MY01 Monitoring Report

Longhorn Riparian Buffer Mitigation Site

DMS Project No. 100114

**Re: Longhorn – Task 5 MY 1 (DMS Project No. 100114)
Response to Comments**

Figure 9
Current Condition Plan View

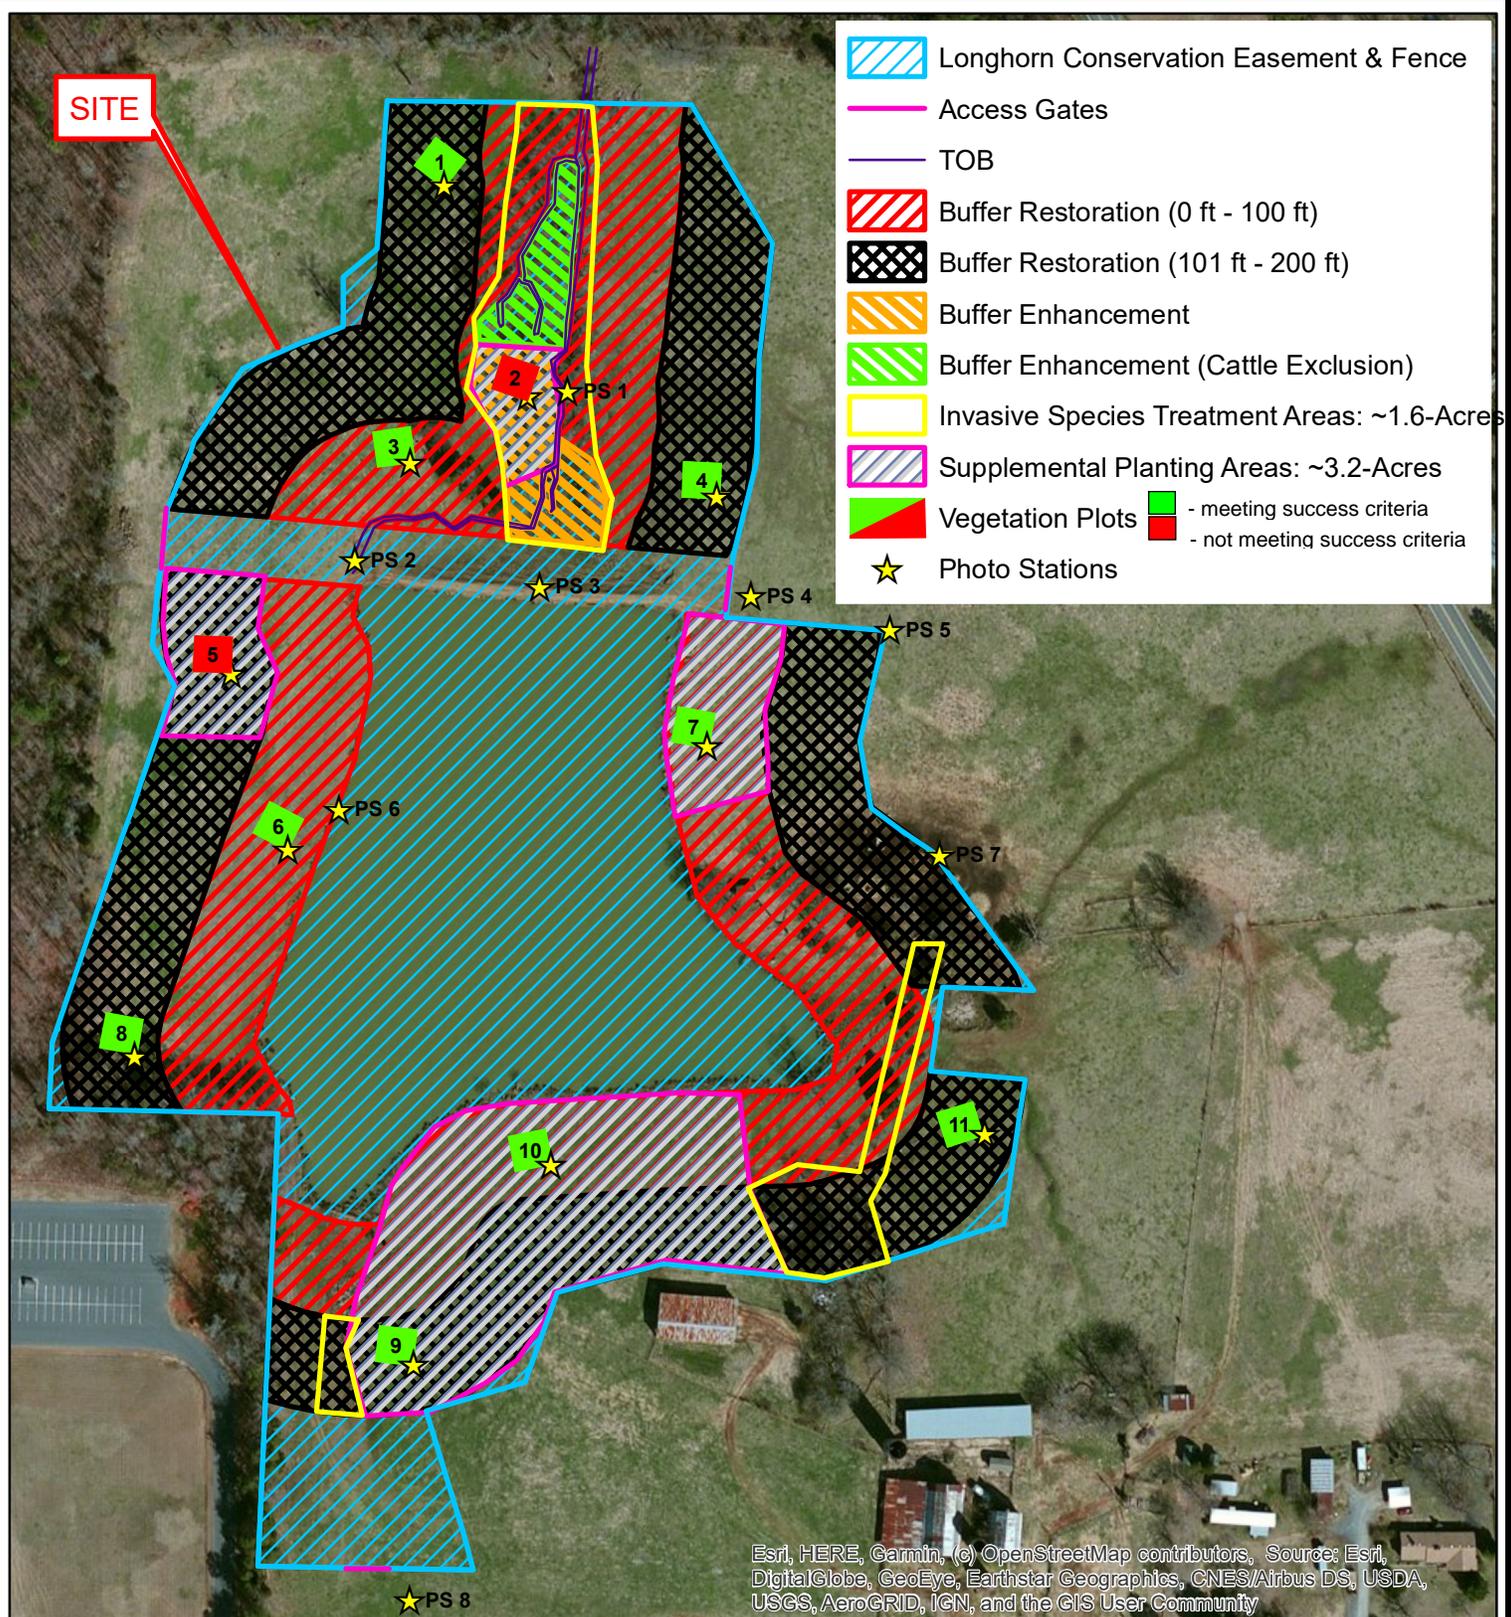
4. Figure 9 – We recommend color coding veg plots on the CCPV based on whether they met success criteria or not. For example, green for meeting and red for not meeting..
Re: The veg plots on Figure 9 have been color coded per the recommendation.
